January 9, 2024

City of Sidney
Parks and Recreation Committee

RE: Sidney Tiger Sharks
Svarre Municipal Pool Permanent Bulkhead
Engineering Commentary from 8-29-23 Meeting
ie# WR22-04-097

Sidney Bulkhead Structure Analysis

POOL CROSS SECTION
1/4" = 1'-0"

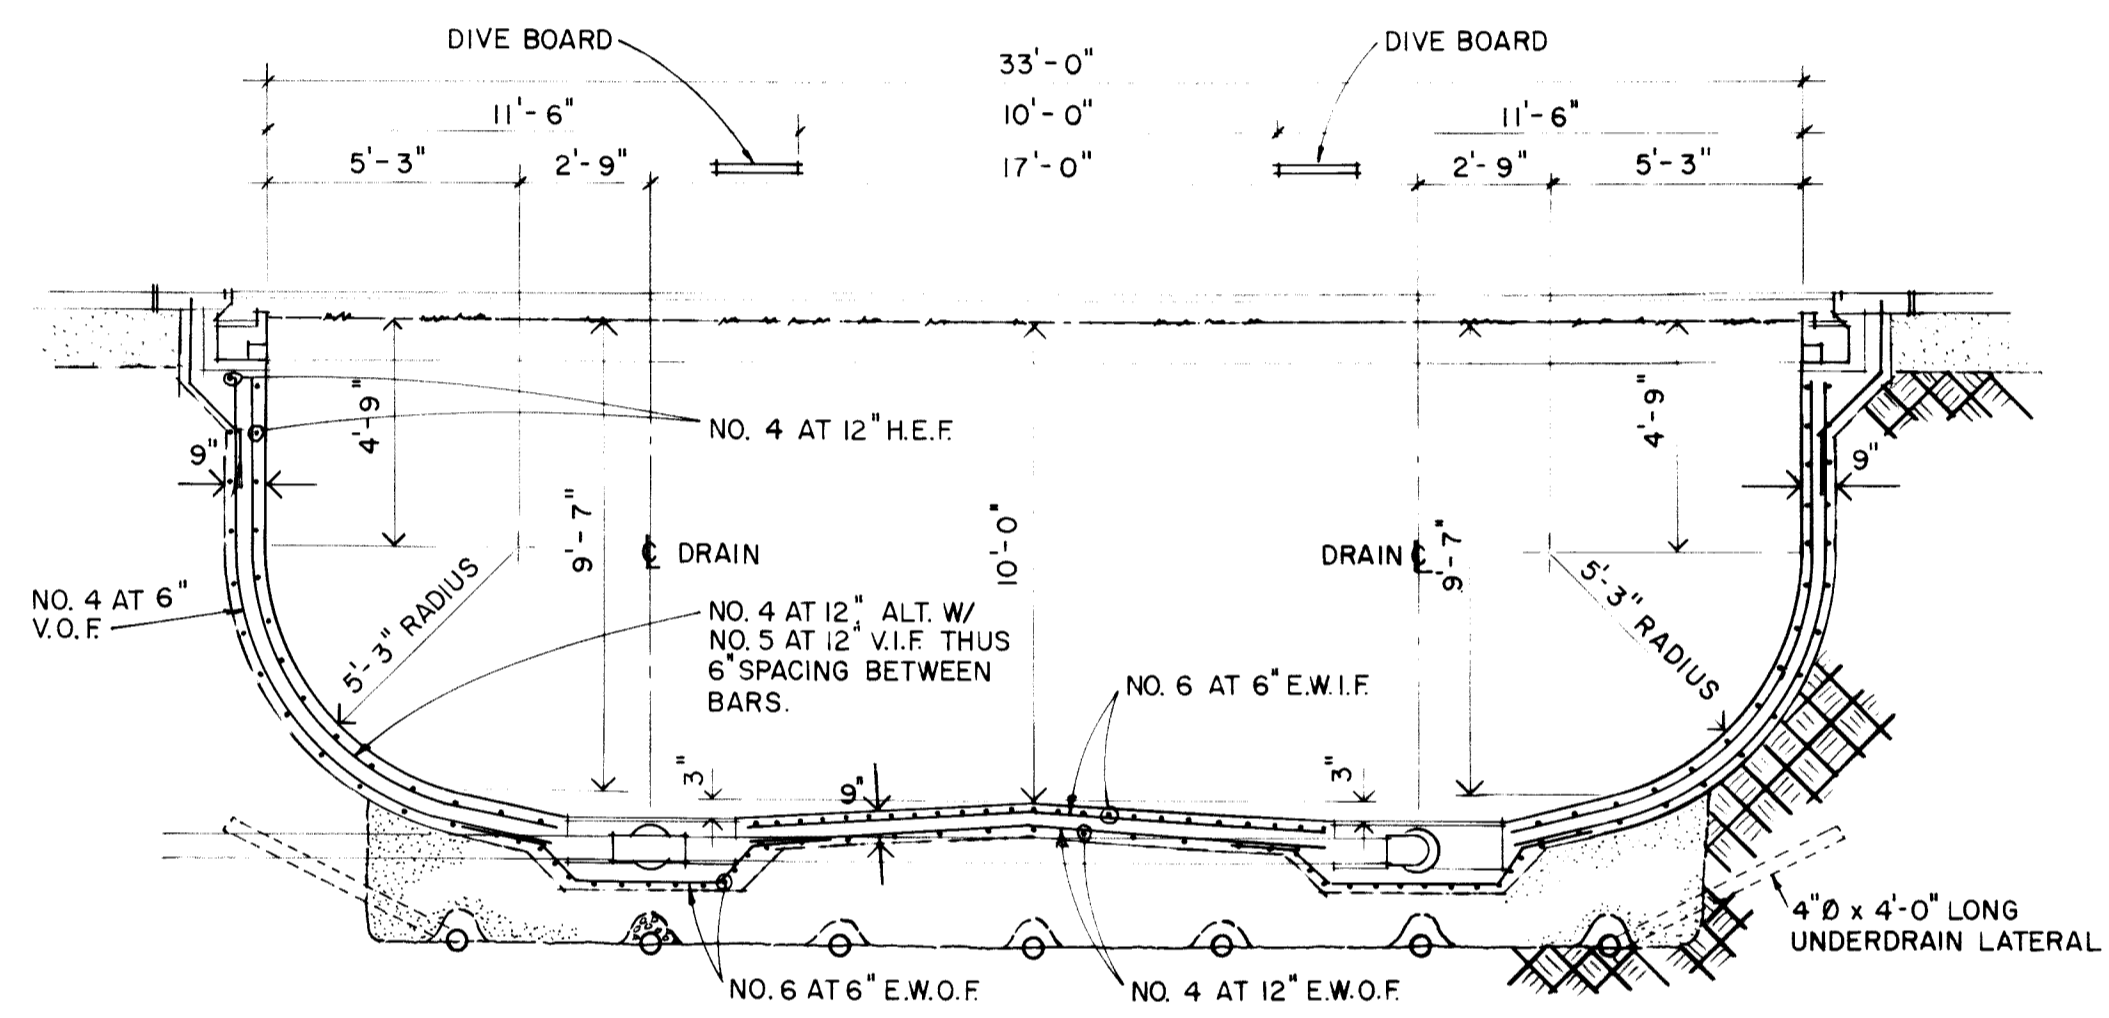
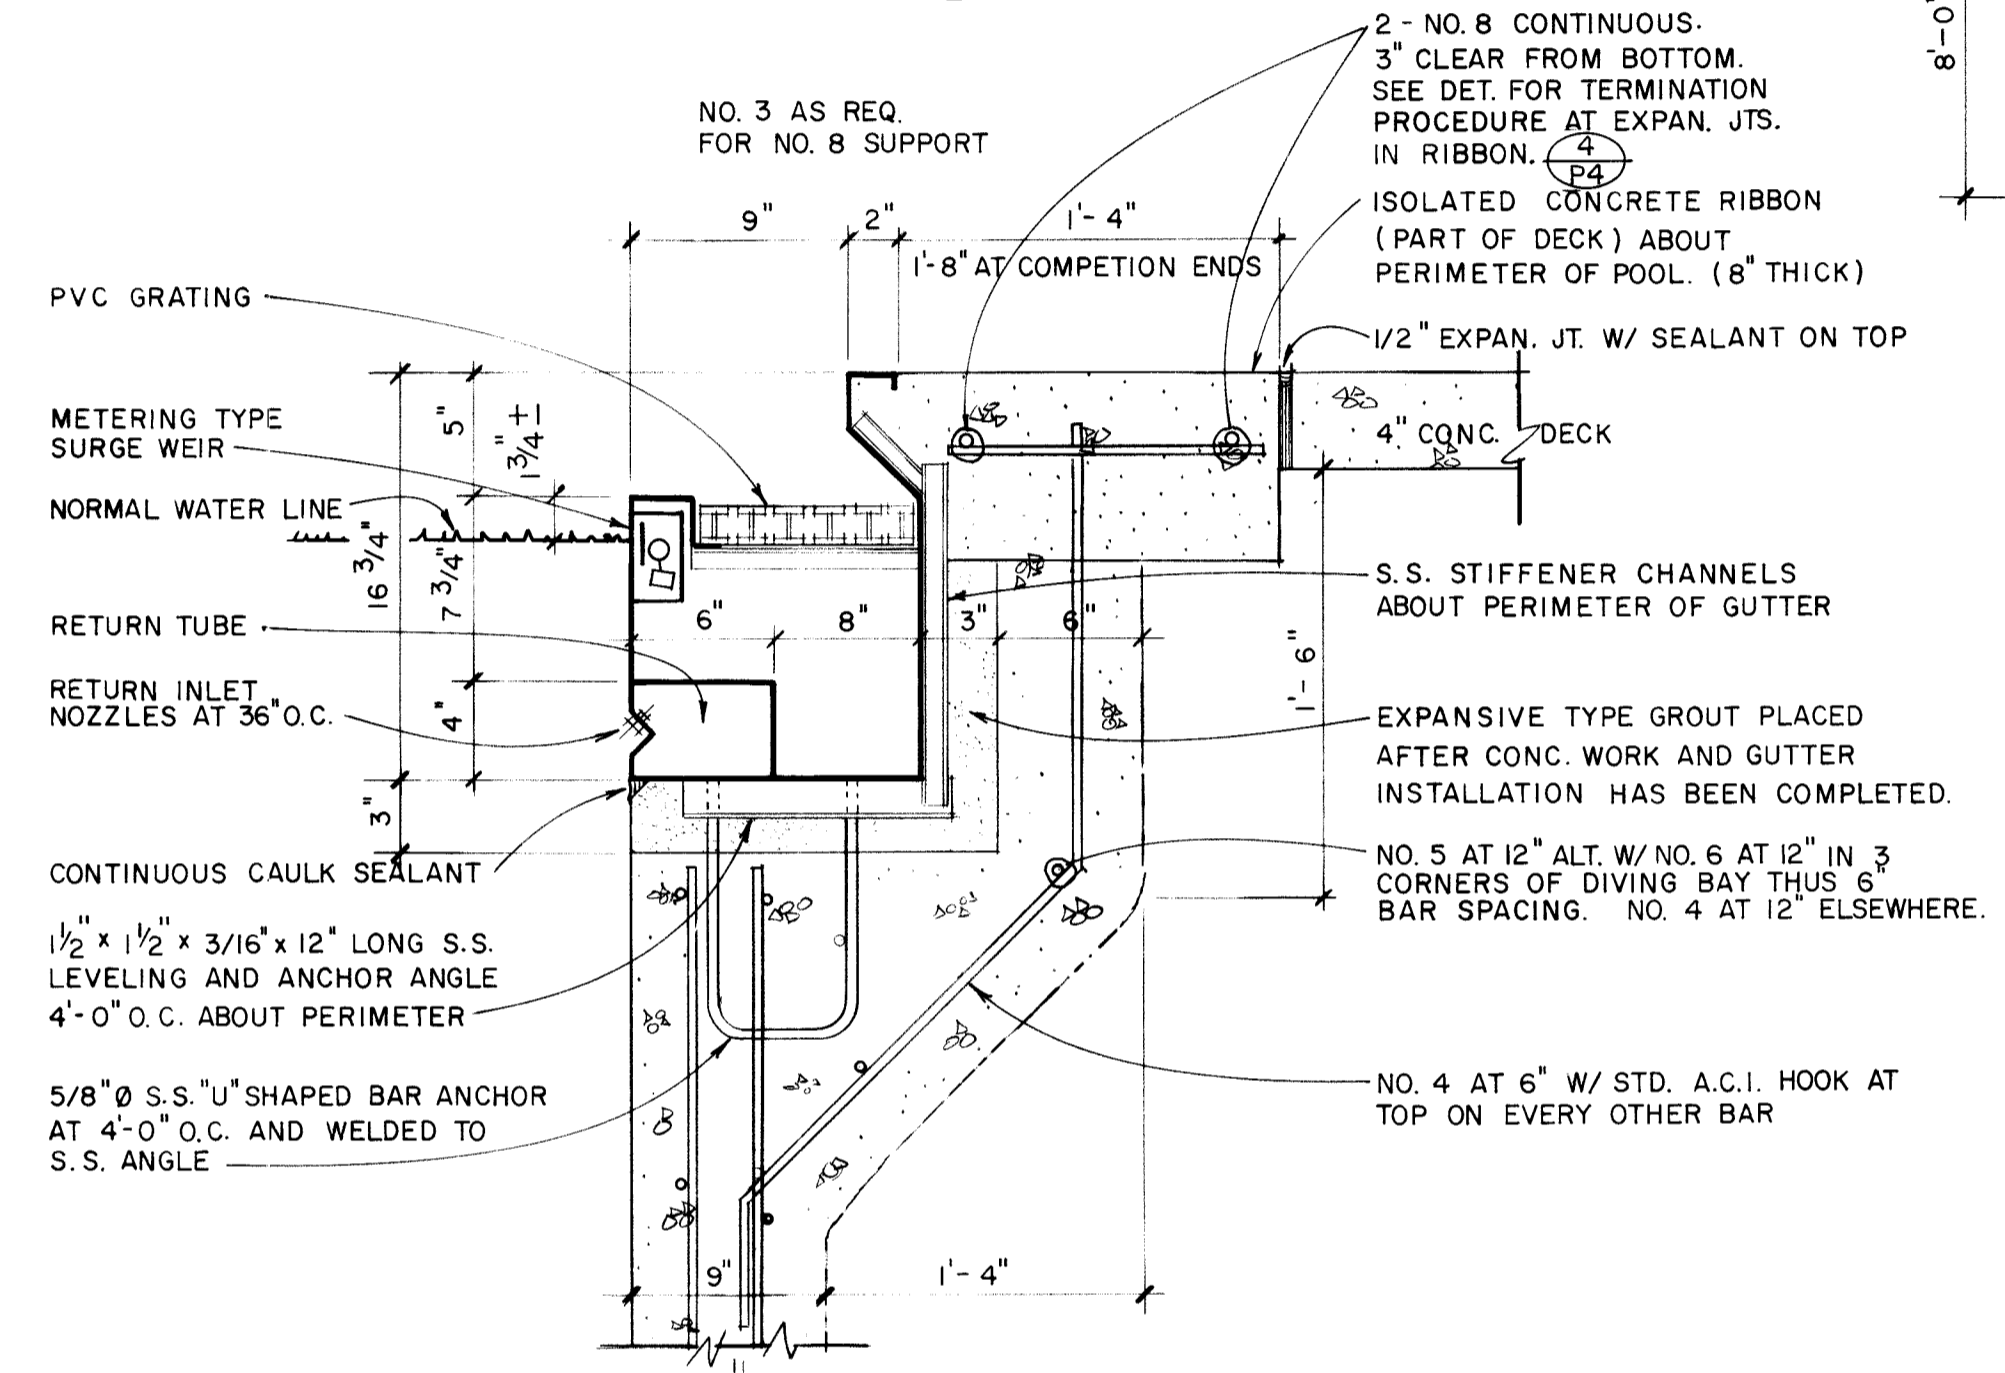
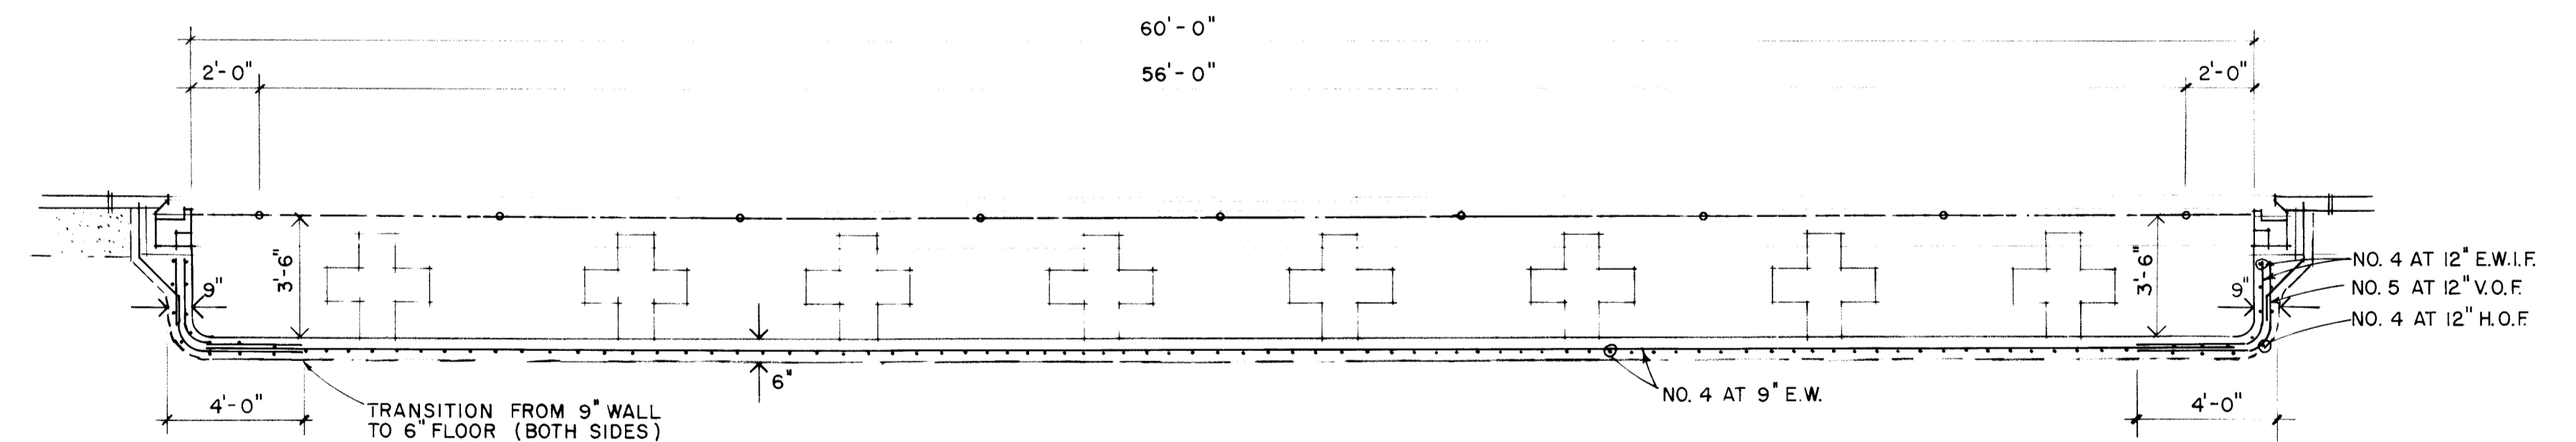
c. Is there a chance that any gravel under the slab is gone now?

The pool floor was constructed on unexcavated/undisturbed earth. Refer to Pool Cross Section 1/P3 within Attachment #5.

There is no piping under the pool floor that could have broken and cavitared the slab.
